B99-000106

PLAN REVIEW COMMENTS

Re: Plan Check Review: **SFD ADDITION + REMODEL & NEW GARAGE**
TOLLOCK RESIDENCE (First Recheck)
Address: **1 ORCHARD STREET**
City Number: **B99-000106**

Re: Plan Review: SFD ADDITION + REMODEL & NEW GARAGE
TOLLICK RESIDENCE

Roof Plan
1/2" = 1'-0"
NOTE:
Roof to comply
w/ Table No. 15-B-2

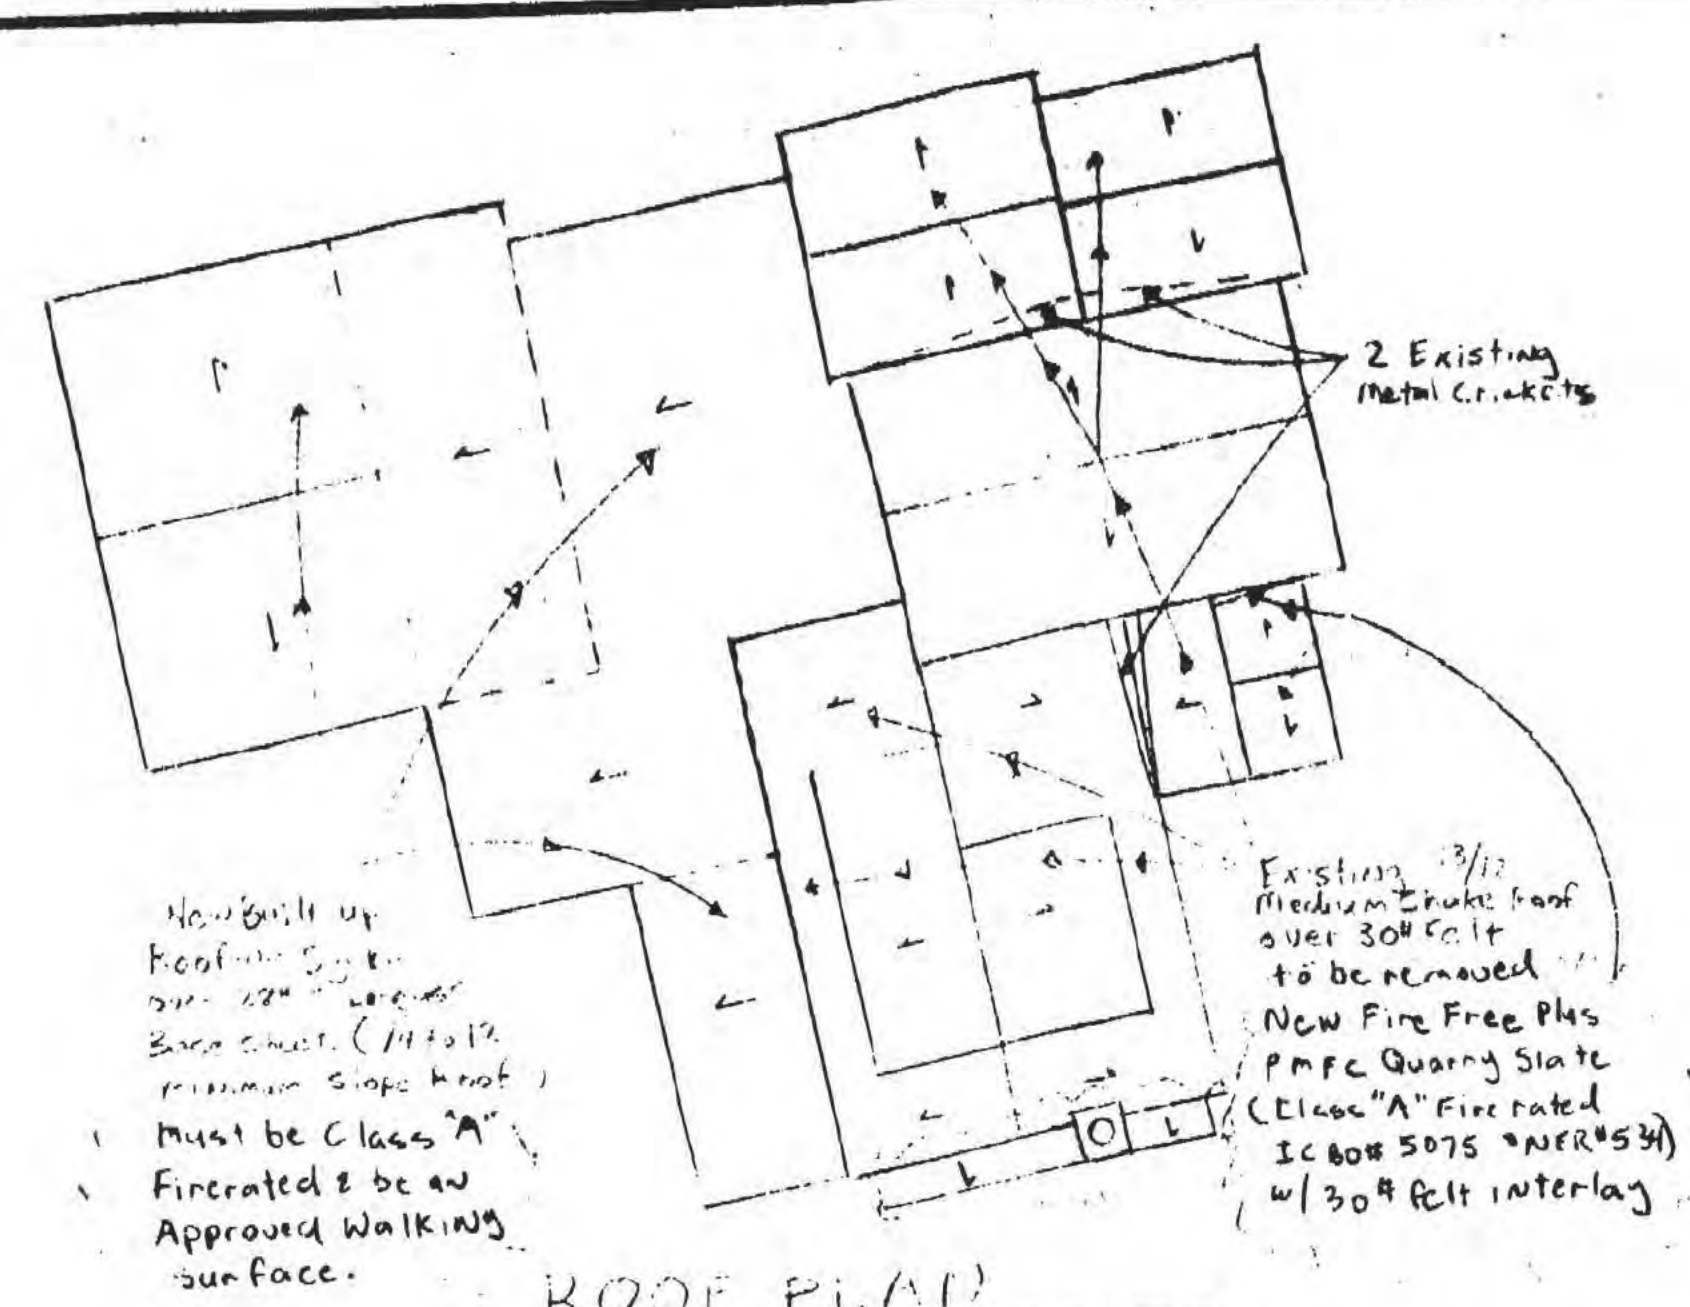
2. Provide manufacturer and UL or ICBO number on the plans for the roofing with a required Class A or better rating per Town ordinance. Indicate the Grade, length, species, and type of shake per Section 1507.13. Indicate compliance with Table No. 15-B-2. Built-up roof deck shall be approved for walking surface and Class A fire-rating.

SITE PLAN
1/8" = 1'-0"

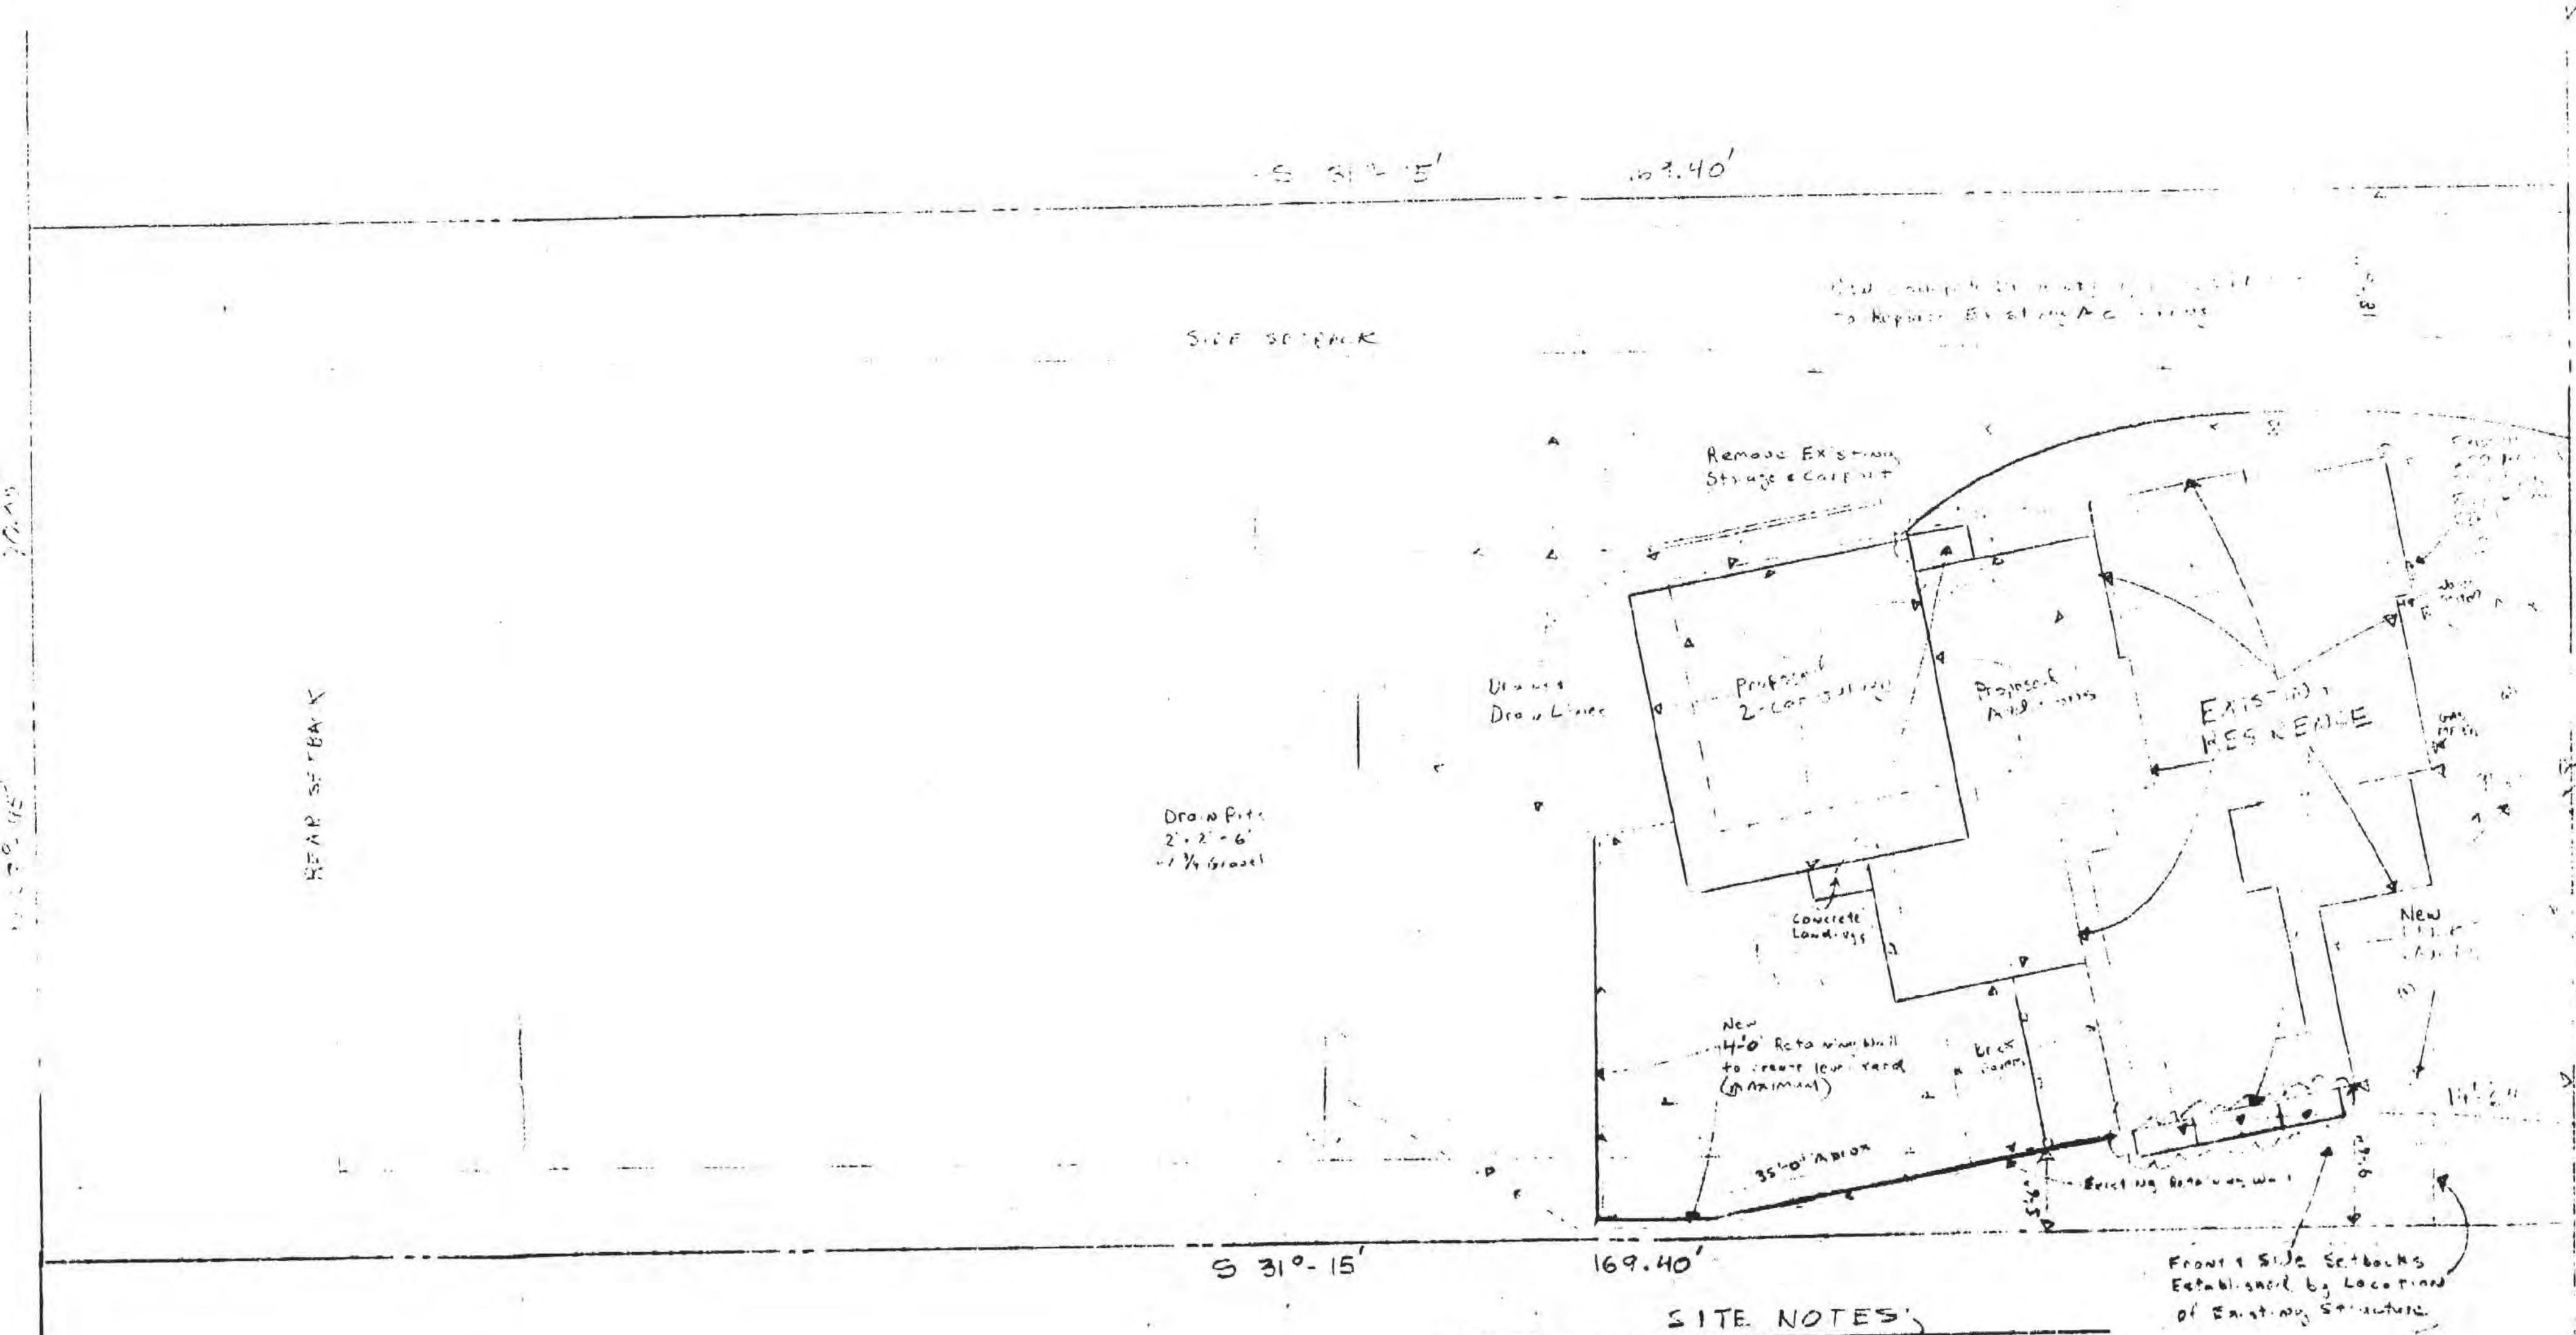
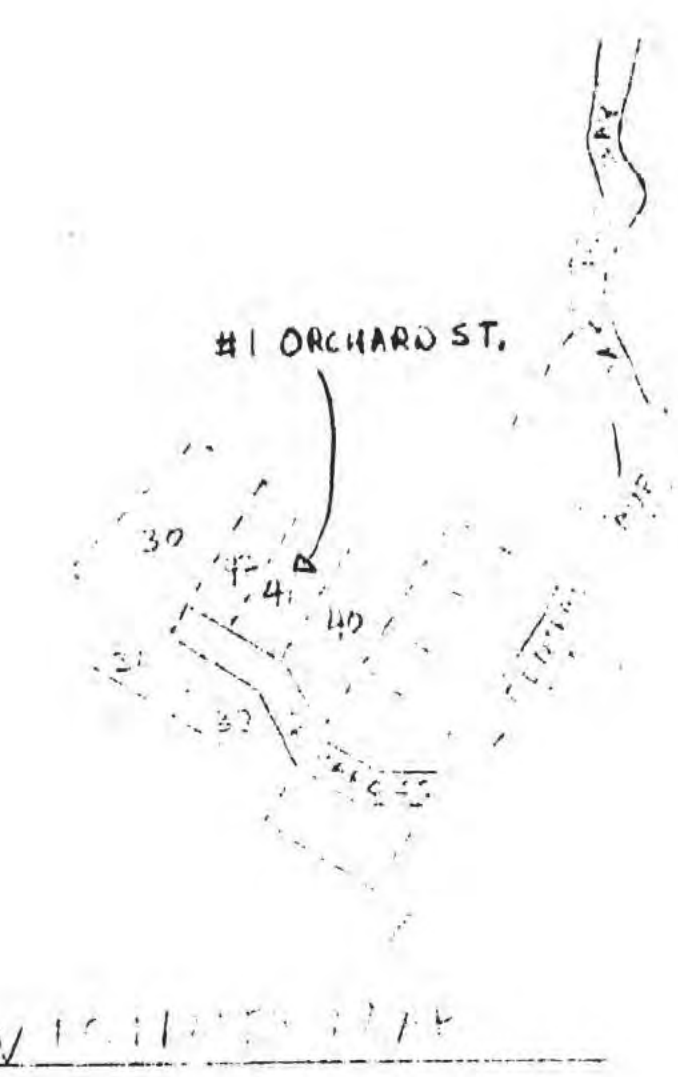
1. Indicate subject lot on vicinity map. See sheet 1.
2. Show fireplaces on site or roof plan.
3. Show extent of deck at rear of house on plan and ceiling heights on section drawing.
4. Provide complete details for the proposed stairs in the public right of way. Detail stair width, rise, run, handrails, etc. City Public Works Department shall approve work in right of way.

FIRST FLOOR

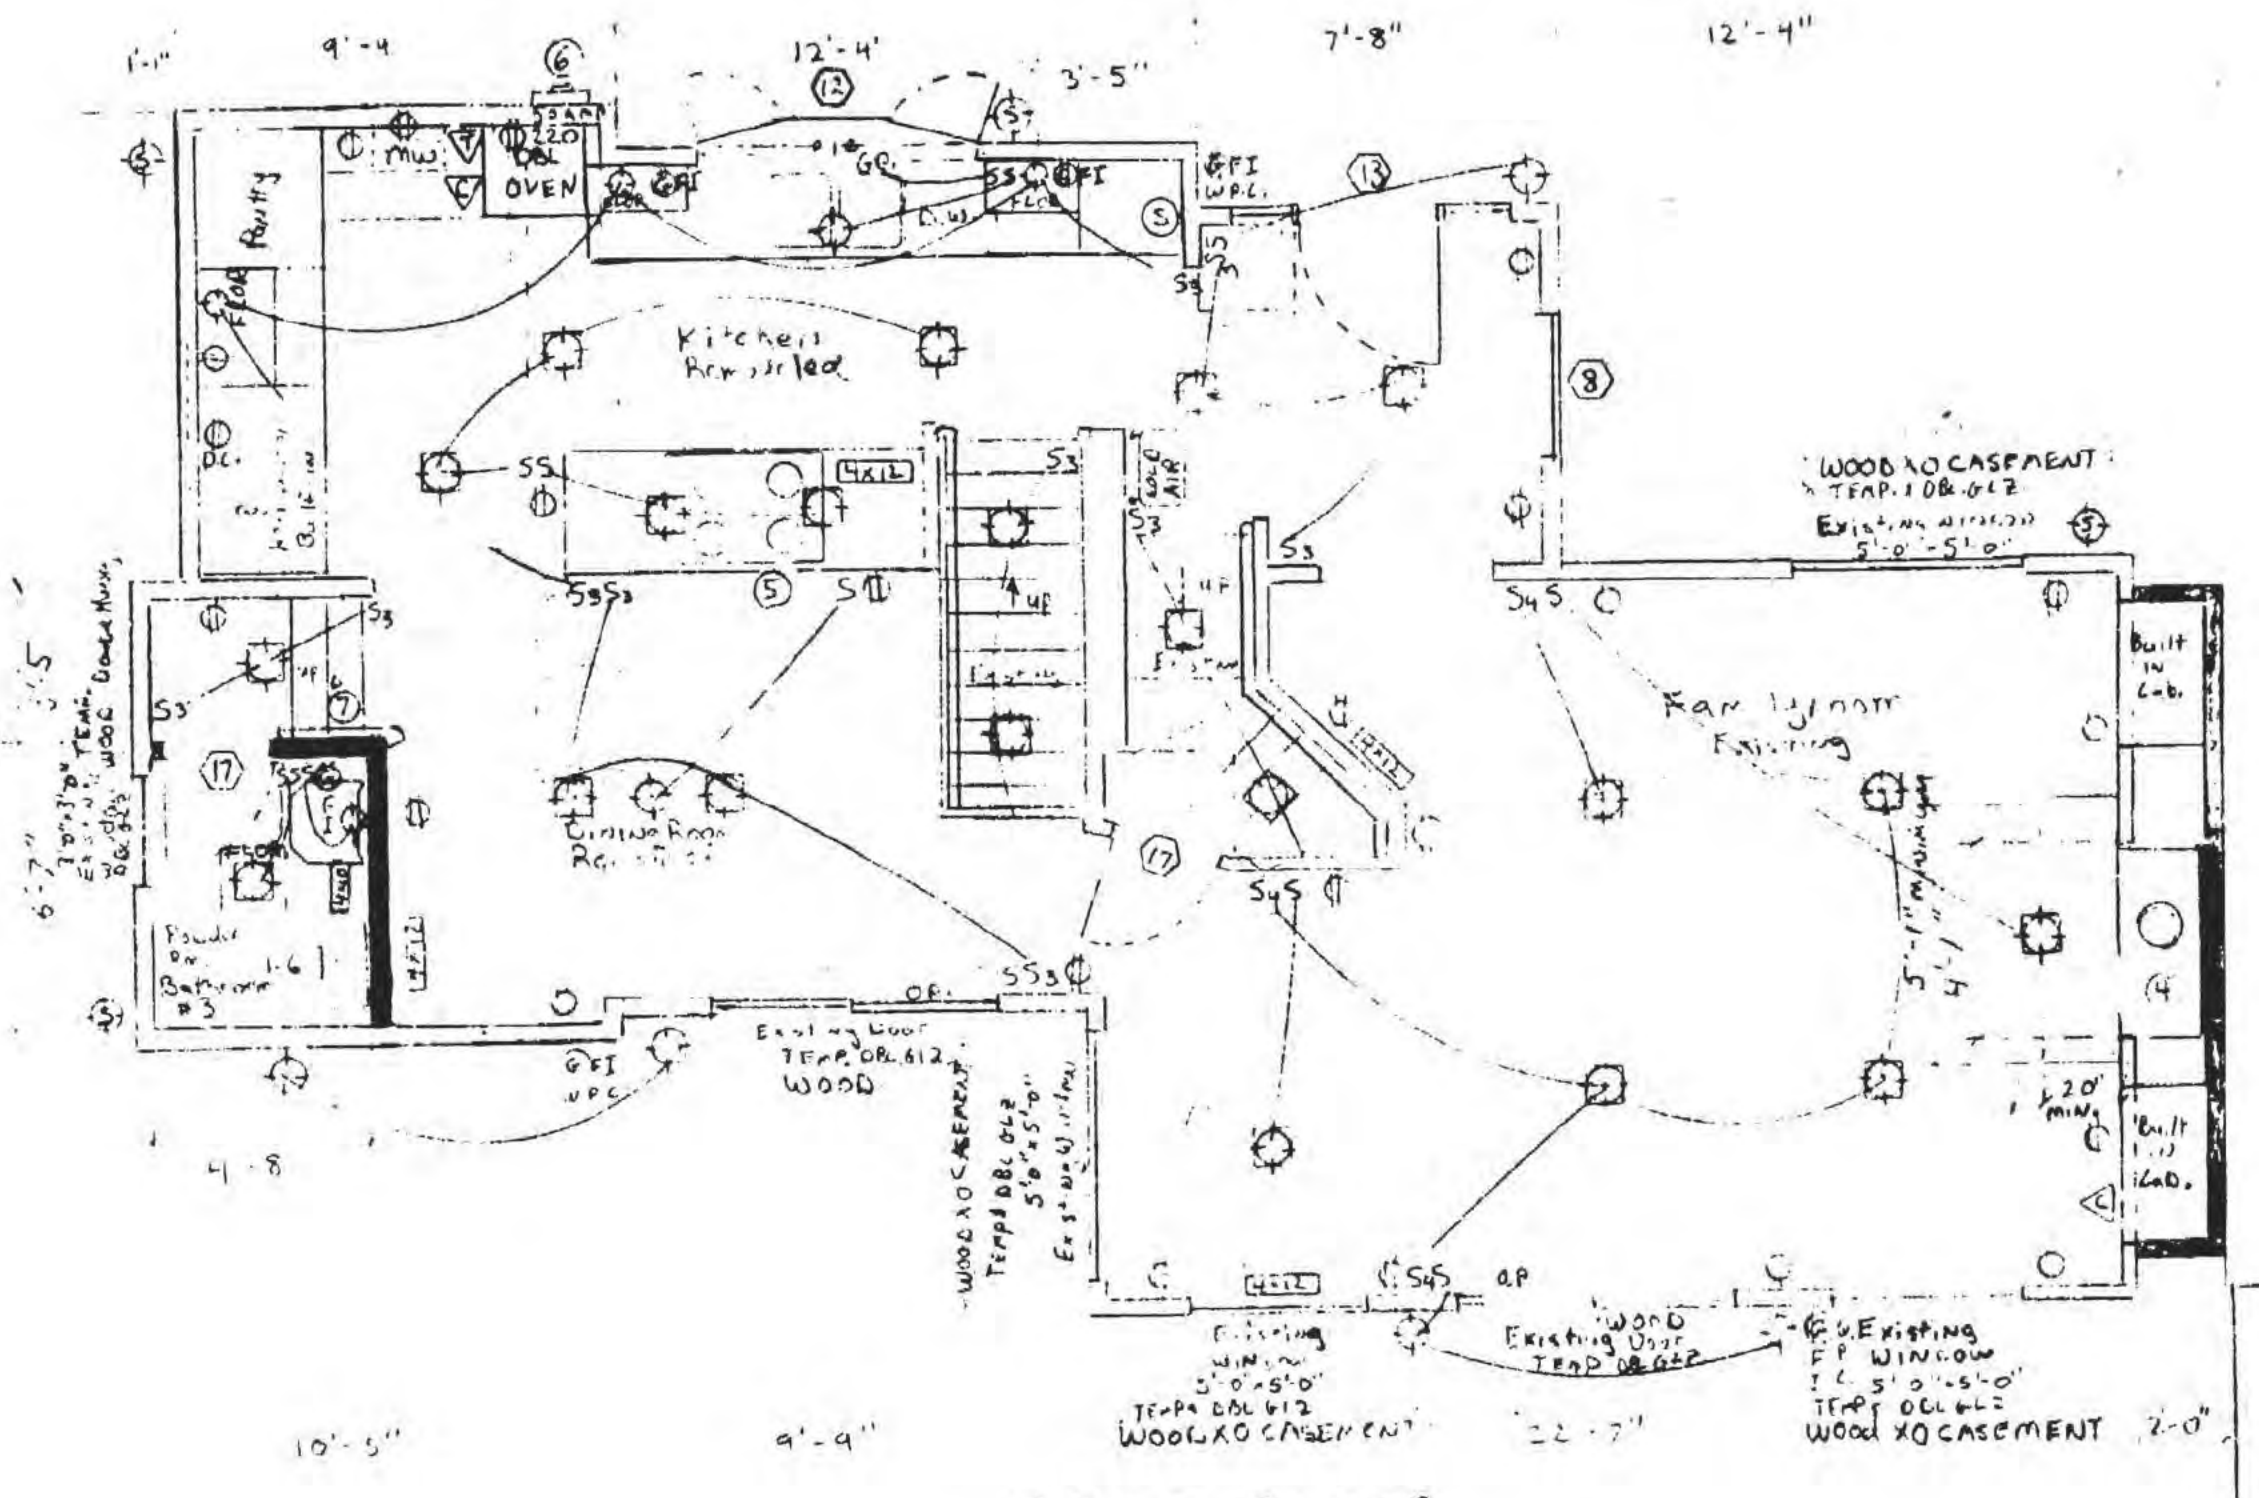
4. Provide safety glazing for windows within 24" of a door. See window at bathroom #3 on first floor and window #3 by door 17 in bath 1.
5. Clarify and indicate on plans all existing window types.

11. Indicate the rise and run of new steps. See steps by new bedroom 2.

- 6) Existing 200 Amp Service Panel (Overhead)
- 7) See Notes, Stairways & Handrails, RISE 7" (total 21") & RUN 11" (total 22")
- 8) All Bathroom each protected by a Dedicated GFI circuit. (Notes Sheet 8)
